Request for Proposals No. 24-05

Bartlet Mall Swan Fountain Restoration Project

Addendum #1

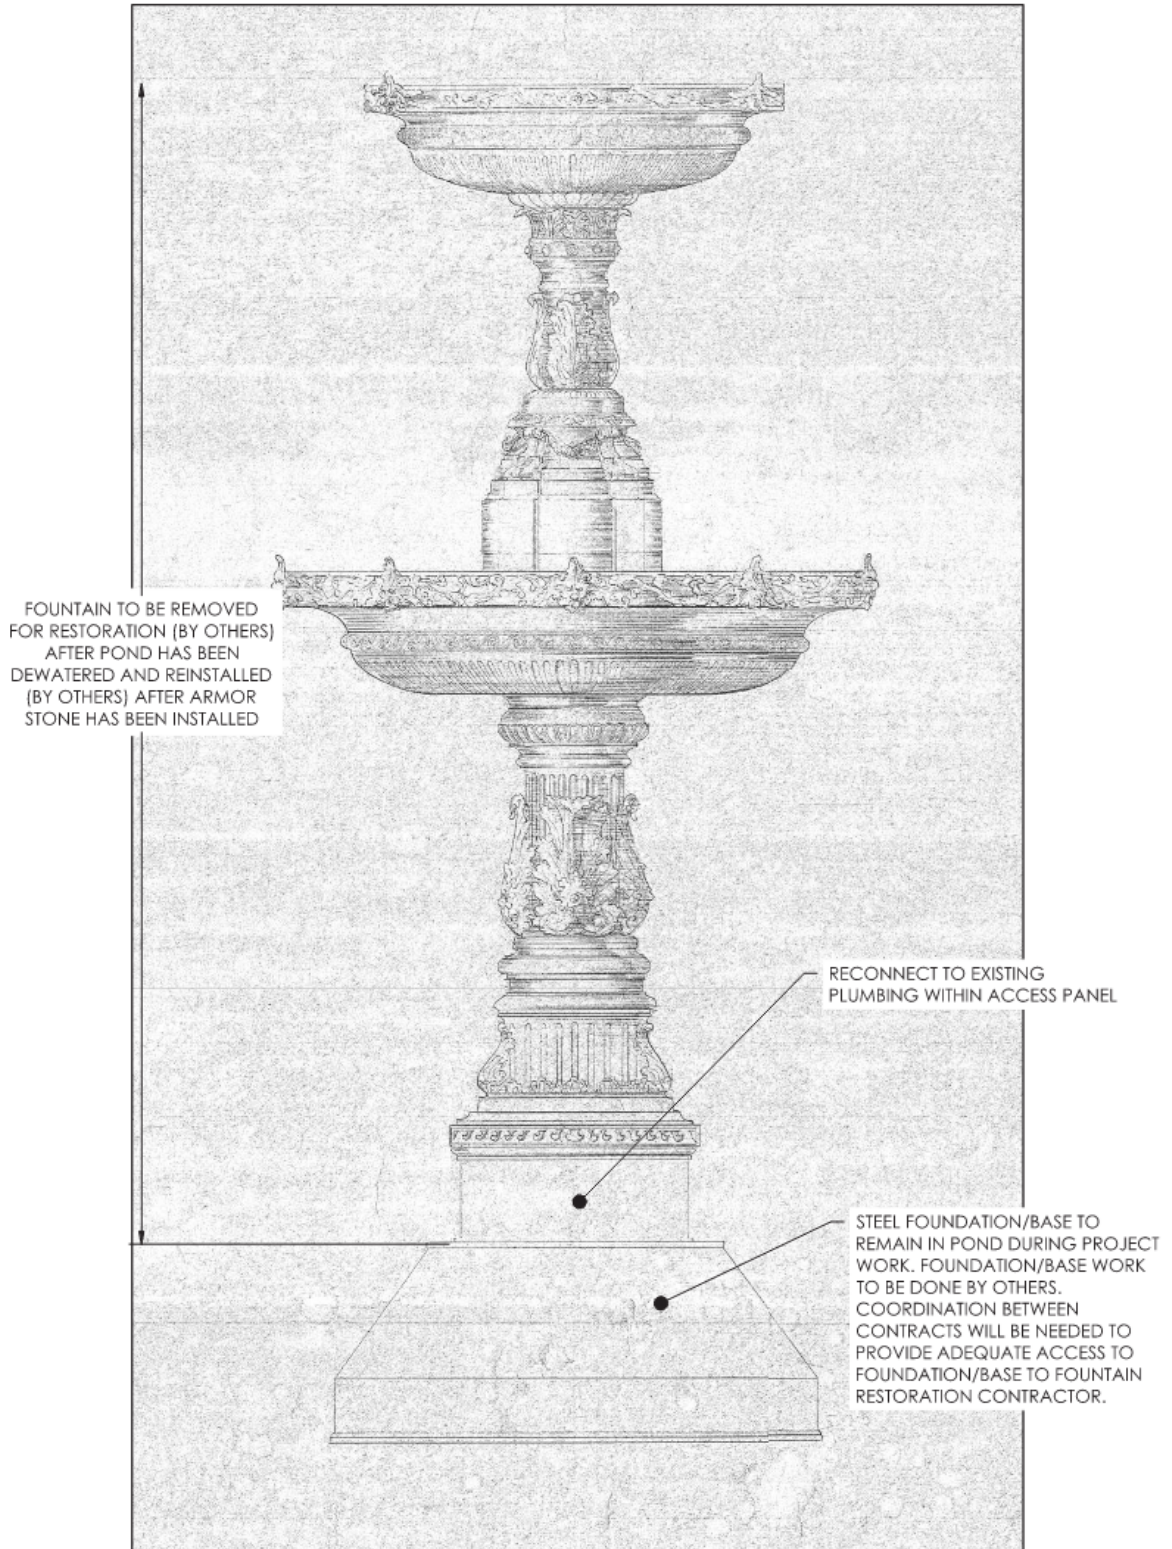
2. Regarding the plumbing, pumps and access to the pump location I have heard that it is located under the court house, if that is correct how do we get into the area to inspect the pump and plumbing if you want to do a test on the fountain per the specification? What is the condition of the plumbing and if it needs repair or replacement who will handle that?
A: No access to the Courthouse is anticipated under this project. A 2-inch HDPE recirculated water line will be provided (under separate contract and by others). The alignment of said pipe is shown below in green:

The reconnection to this stub is anticipated to be as follows:

Should the pipe within the fountain need to be repaired/replaced, that would be handled via Changer Order due to unforeseen conditions.
